SUMMARY OF: P920015/S093

MEDTRONIC MODEL 5019 HIGH VOLTAGE SPLITTER/ADAPTOR KIT

EXECUTIVE SUMMARY/BACKGROUND

Proposed Model 5019 Splitter/Adaptor Model 6726 Approved Splitter/Adapter

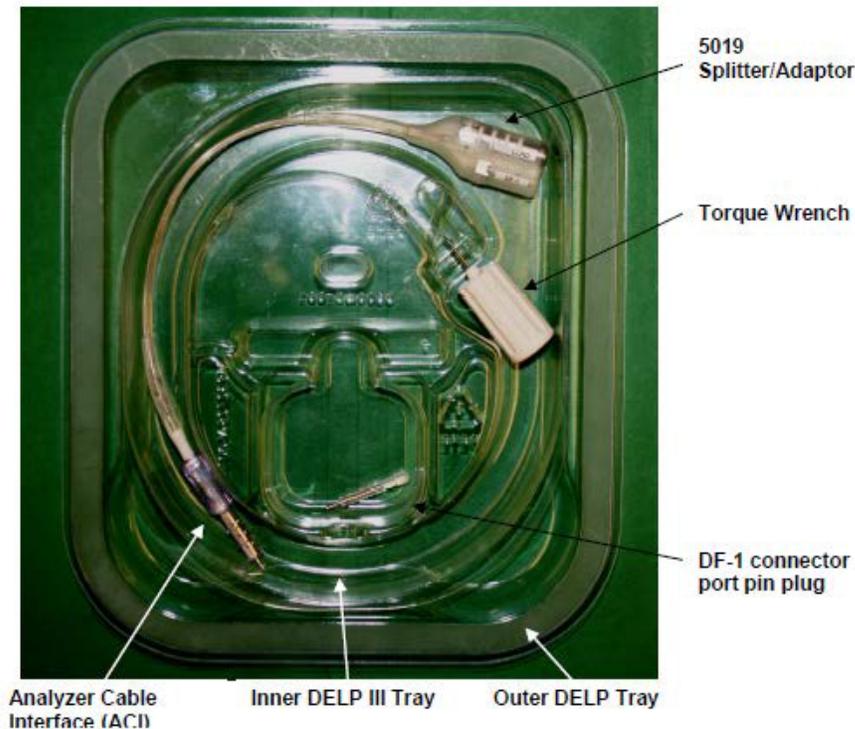
LEAD REVIEWER COMMENTS: *The comparisons of the 5019 lead adaptor to the approved 6947M lead (male DF-4 connector and lead body) and ICD ports (female DF-1 and DF-4 connectors) was very helpful. The difference with the male connector is a squared off pin which was not a concern. The difference with the lead body is the (b)(4) Trade Secret but this was not a concern since (b)(4) Trade Secret is only a manufacturing aid to assemble the much longer 6947M lead. The female connector molding at the distal end is the part of the adaptor with the most changes compared to existing devices. It is helpful to understand that the internal port*

components and set screws are similar or identical to those used on ICDs. The testing of this region will be reviewed to assure that the adaptor as built will meet the functional requirements. There are no questions regarding the similarity and differences of the 5019 adaptor to other devices. The two minor design changes proposed to aid manufacturing and reduce loss are minor with regard to tolerance stacking and I agree they do not impact conformance with ISO-27186 and are not likely to impact safety and effectiveness pending satisfactory completion of testing which will be reviewed below.
